## INSTRUCTION TO SERVICE

<b>ITS: 5173</b>	
<b>SECTION:</b>	219 Engine and Transmission
<b>WRITTEN BY:</b>	Shaun Cardinal
<b>SUBJECT:</b>	UCAP Cabinet Cover (Legacy)

# ITS5173

**Fig 4 – UCAP Lid Hardware**

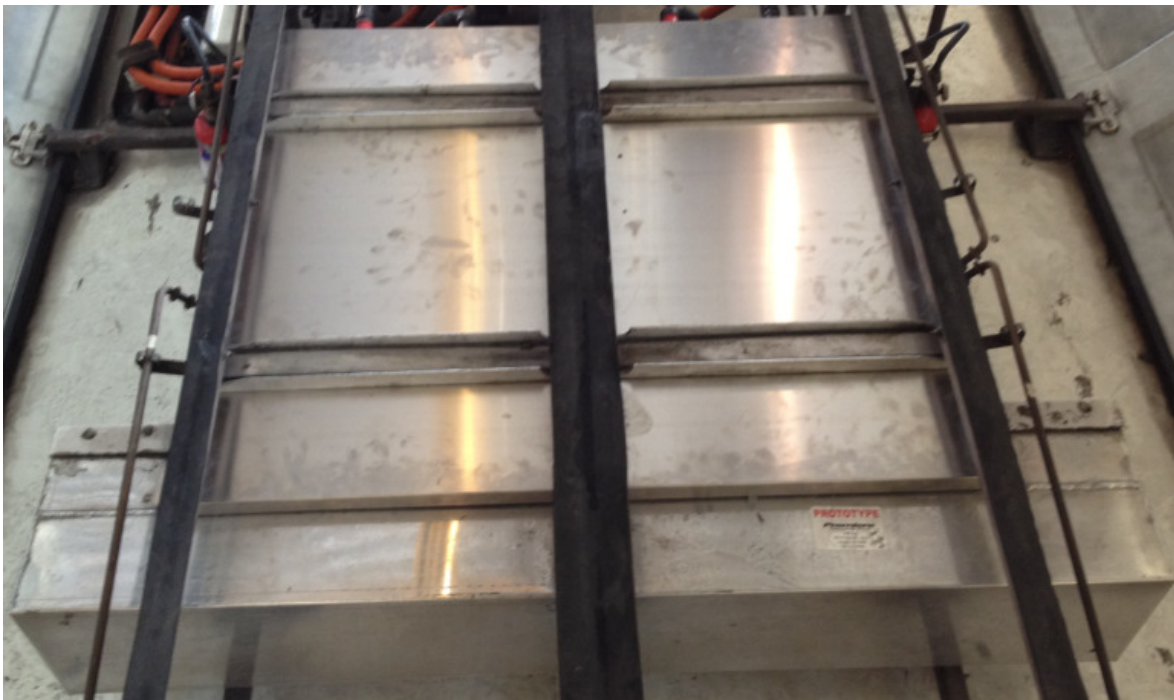
- e. Remove all existing perimeter hardware (16x screws, washers, and lock washers per UCAP) securing the UCAP lid to UCAP box (Fig 4).

**⚠ NOTE:** Do not remove lid as it will break the weather tight seal.

- f. Replace hardware with new low profile hardware (**NFI PN 6409430**). Do not re-use the washers and lock washers.
- g. Install new cover assembly (**NFI PN 490384** and **NFI PN 5957793**) to the UCAP assemblies per Fig 5 and 6. Reverse steps b-d for securing UCAP.
